ADDENDUM #2 TO THE TECHNICAL DRAINAGE STUDY FOR THRIVE TOWNHOMES

Project No. 2112062

**Re: Addendum #2 to the Technical Drainage Study for Thrive Townhomes
CLV DS#5527**

Blue Diamond Civil Engineering has received the City of Las Vegas review comments for the above referenced study, dated March 7, 2022. The comments in the subject memorandum have been reproduced with accompanying responses as follows:

FIGURE 10

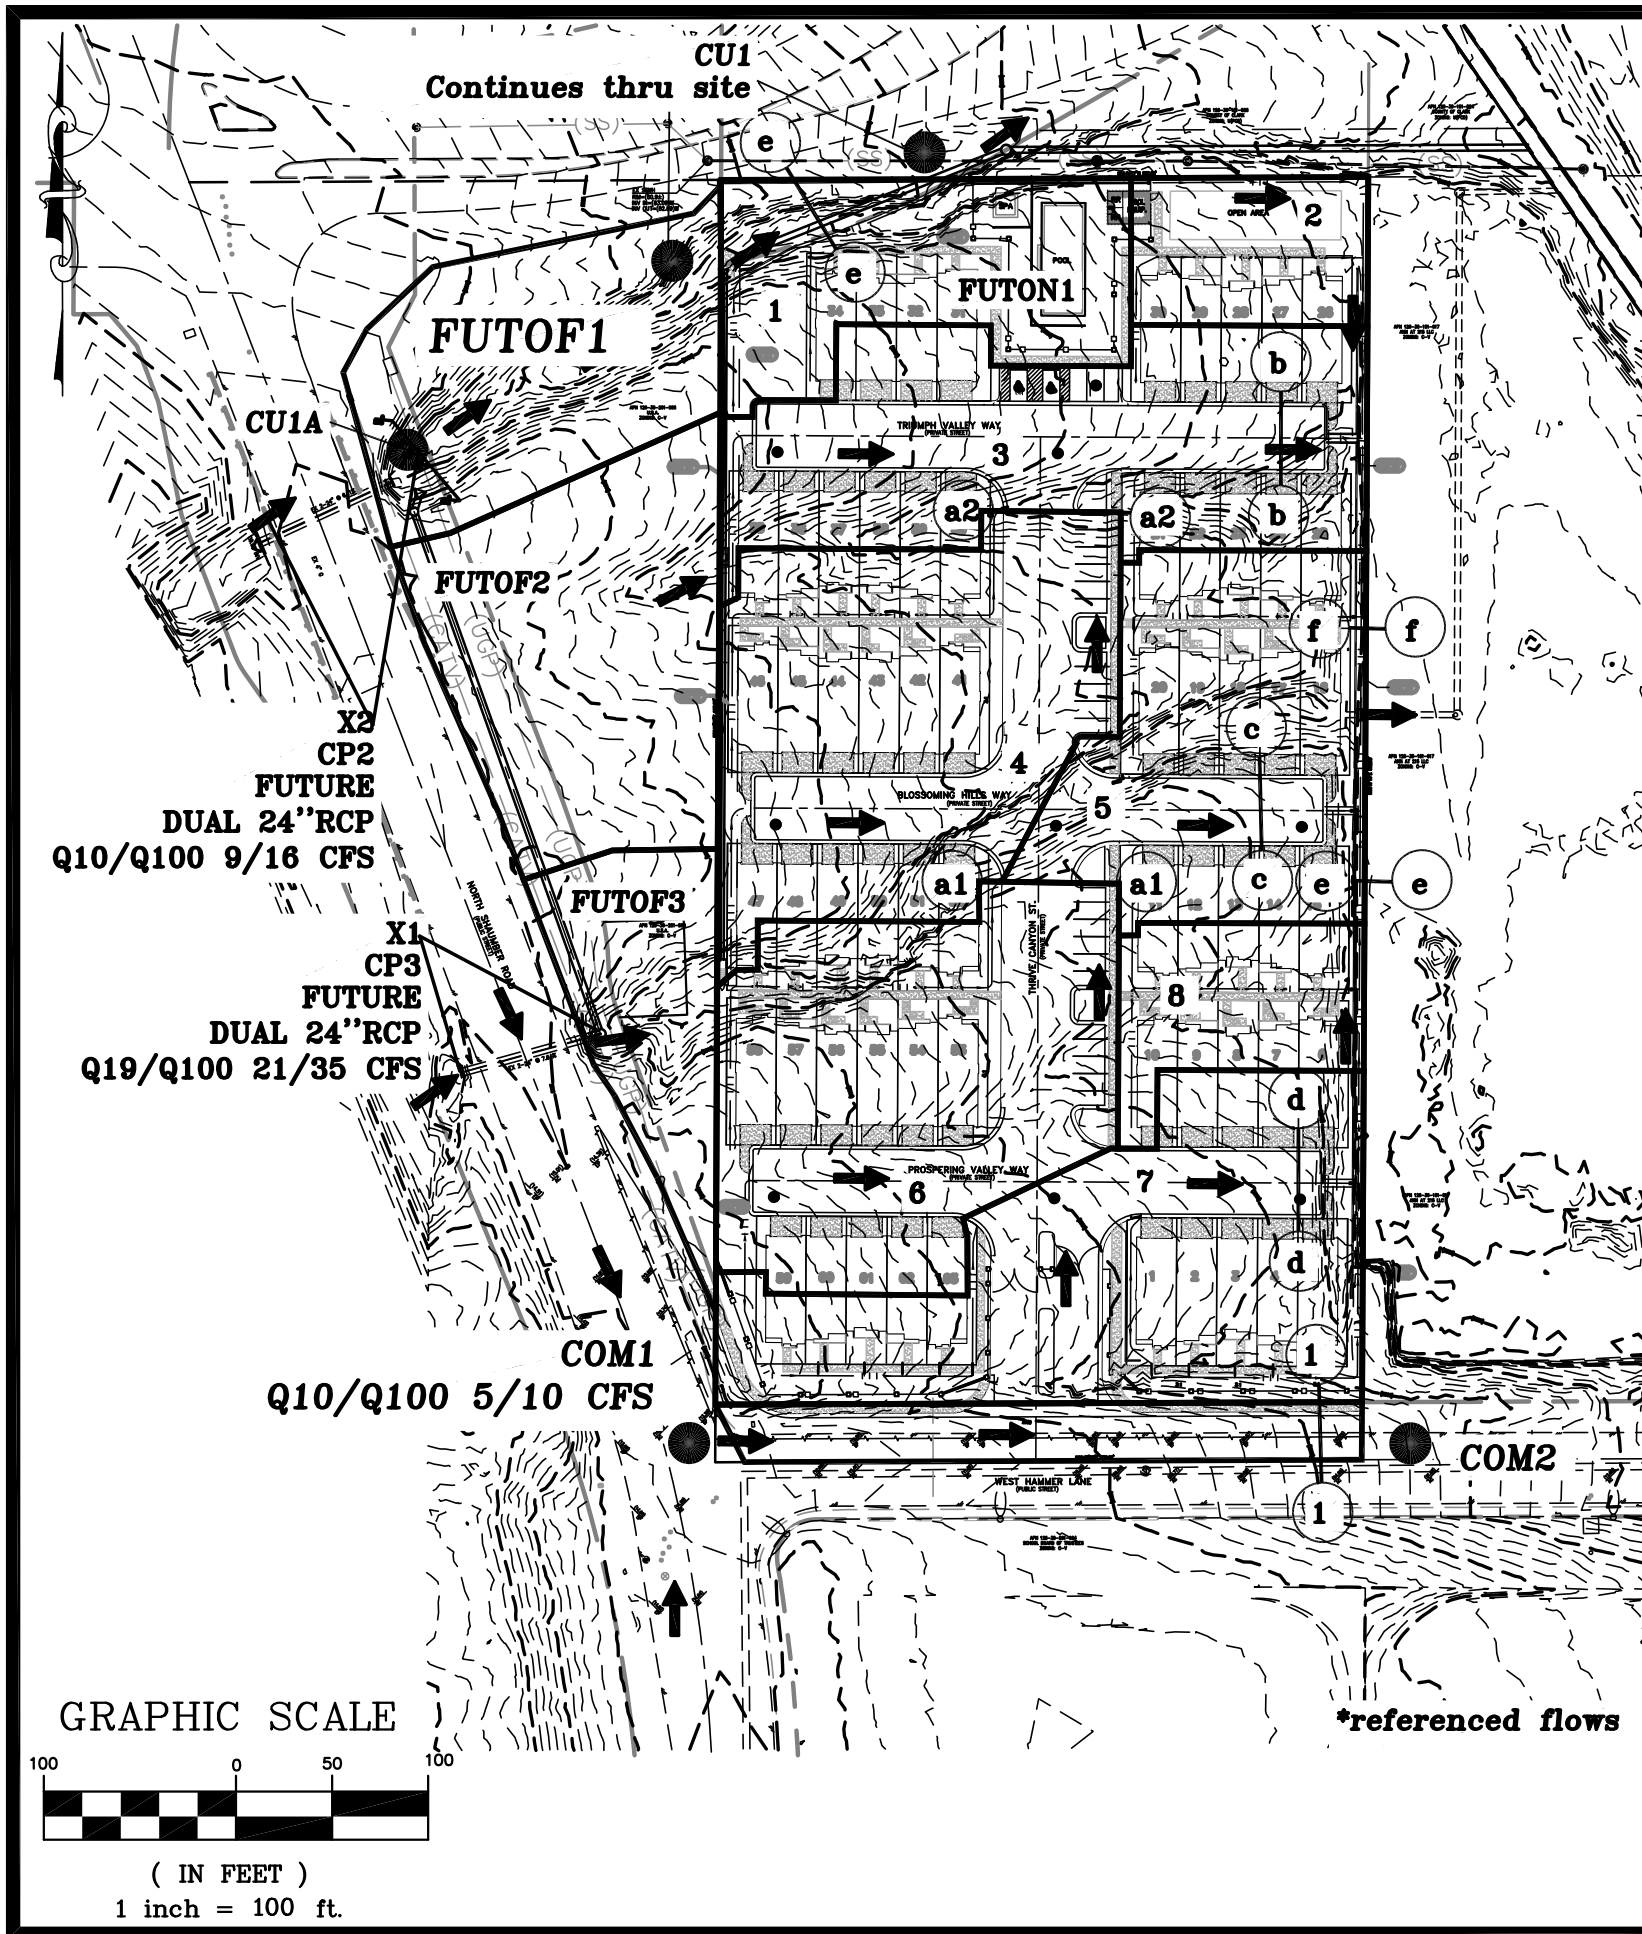
Comment 3: Provide a summary table for prorated subbasin flows including concentration points. Sum of “Onsite Street Flow Calculation” is 115%. Also, depth shown on “Offsite Street Flow Calculations” doesn’t match the Flowmaster calculation. Revise and reflect changes accordingly.

Response 3: The project has been divided into 8 prorated subbasins. The flow patterns have been annotated on the basin maps. The street sections summary table show the concentrated flow and the applicable subbasins that contribute the total flow at the section. The sum of the subbasins is 100%. The Offsite Street Flow Calculations table has been revised to reflect the correct calculations. A summary of the prorated subbasin flows can be seen in the following table:

Worksheet for Add2: 10yr Blossoming Hills Sect c

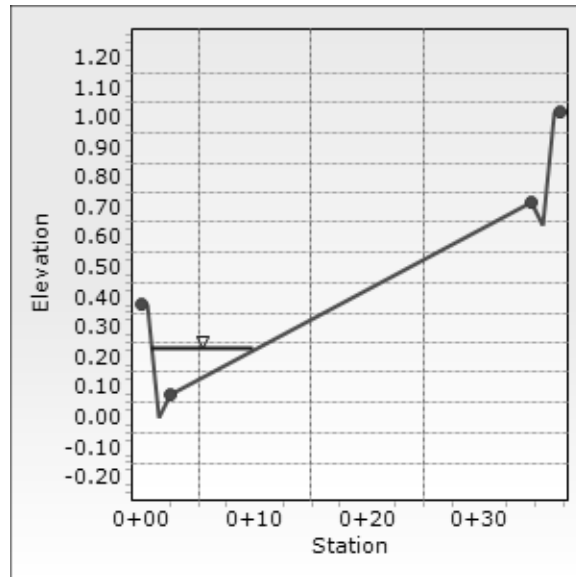
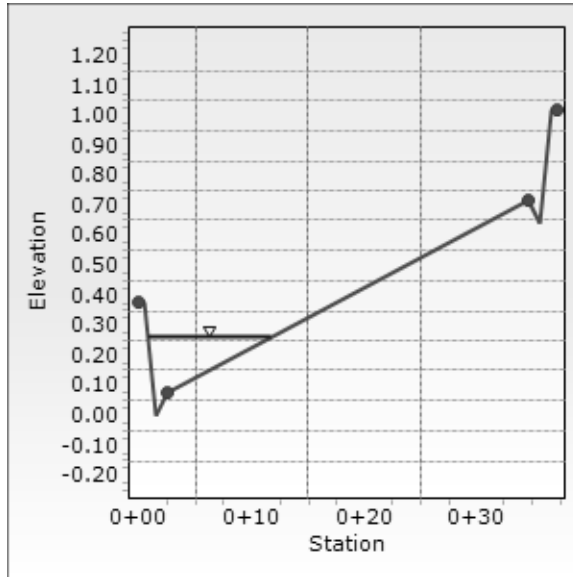
Comment 4: For FlowMaster Section C, revise curb type to match the grading plan.

Response 4: Section C has been revised to match the grading plan and has been included in the appendix. A summary of the calculation has been provided in the response to comment 3.

Worksheet for 30" RCP Outlet Protection

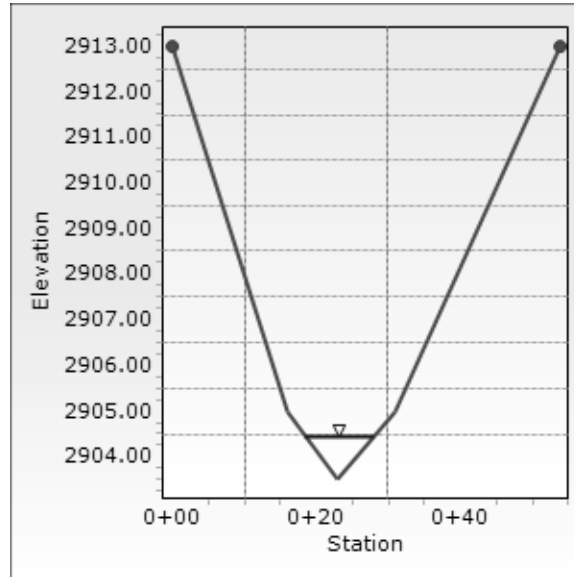
Comment 10: Sheet GP-4: Label TW/BF elevations for all corners around Junction Structure #1 and beginning of 18-inch RCP area. Provide proposed grading along proposed 30-inch RCP. Change manhole callout to Type III (406.1). Provide outlet protection of 30-inch RCP. Provide supporting calculation for Outlet protection.

Response 10: Top of retaining and top of footing elevations have been shown along Junction Structure #1 and the entrance to the 18" RCP SD. The proposed grading has been provided at the SDMH#1 and SDMH#2. However, there is no proposed grading along the 30" RCP SD along Shaumber Rd. The pipe will be installed and the grading will remain as is. The contractor will backfill the pipe to existing grade elevations. All SD Manholes are called out as Type III. The plans show a 10' x 10' minimum Riprap pad of D50=1' and Thickness of 2'. This is more conservative than what is required per the calculations. Supporting calculations have been provided in the appendix.
